FEE: _____ **AUTHORIZATION FOR WASTEWATER SYSTEM CONSTRUCTION**
DATE: _____ **VOID SIXTY (60) MONTHS FROM DATE OF ISSUANCE**

DATE: _____ PERMIT NO: 2881 B
PARCEL NO: 033-086-13 (001)

PROPOSED PLOT PLAN

FILE: 2881 B

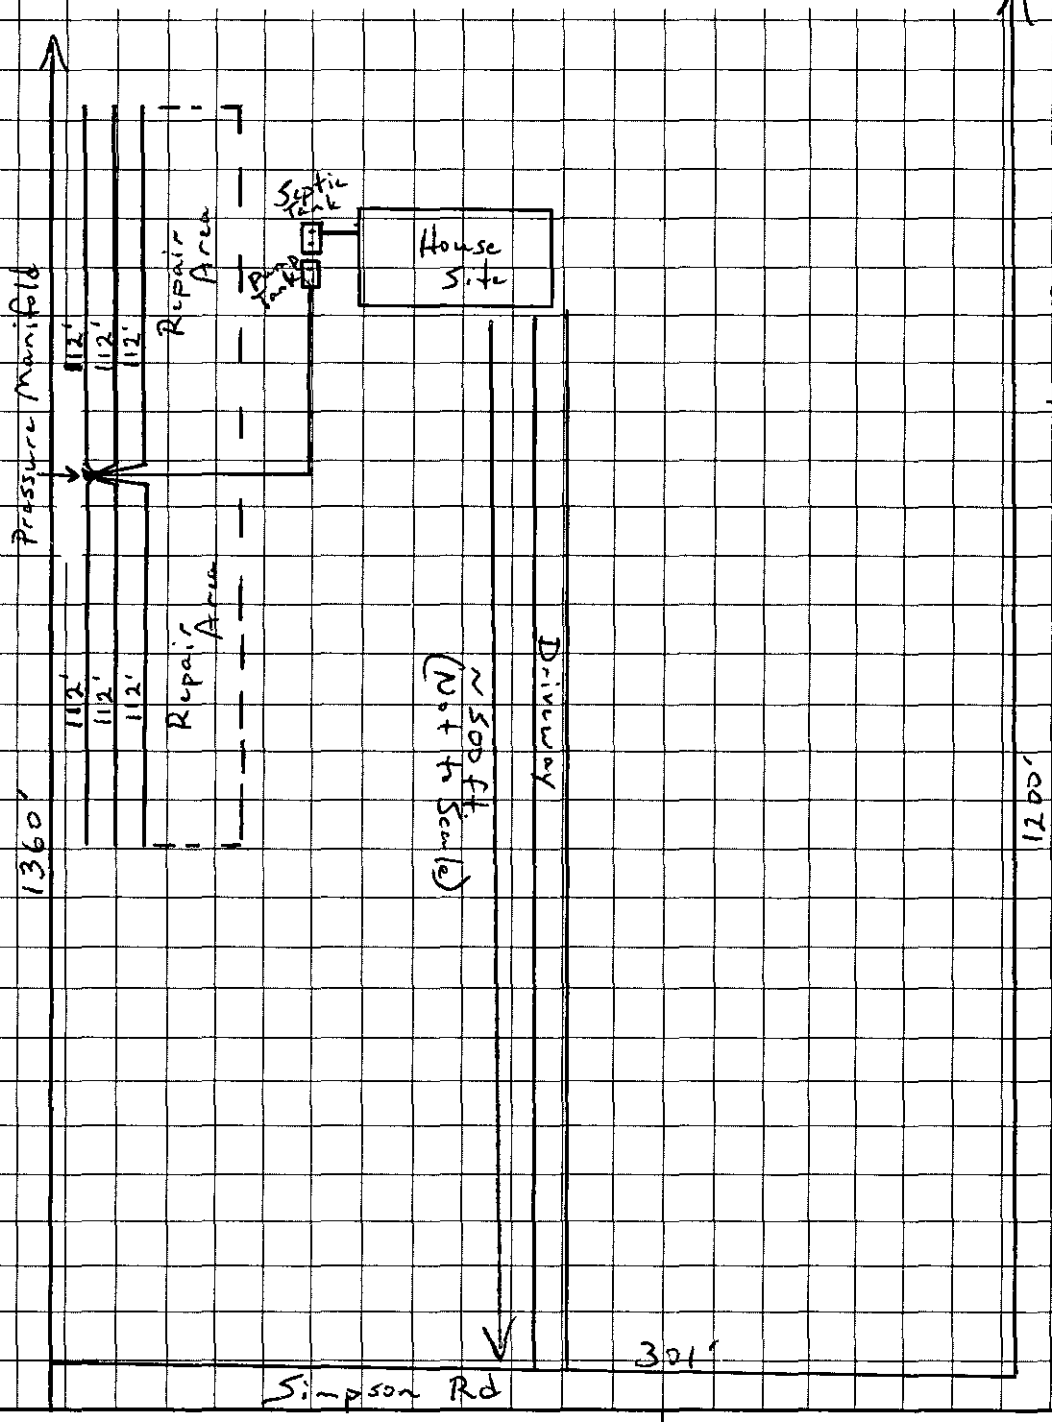
1) Outer boundries not drawn to scale
2) Scale 1" = 60'
3) Keep lines level and on contour of land
4) Keep trenches shallow- 24" maximum.
5) Keep all parts of septic system the minimum distance from the following:
   A) Any well - 100 ft.
   B) Any property line - 10 ft
   C) Any building foundation - 15 ft
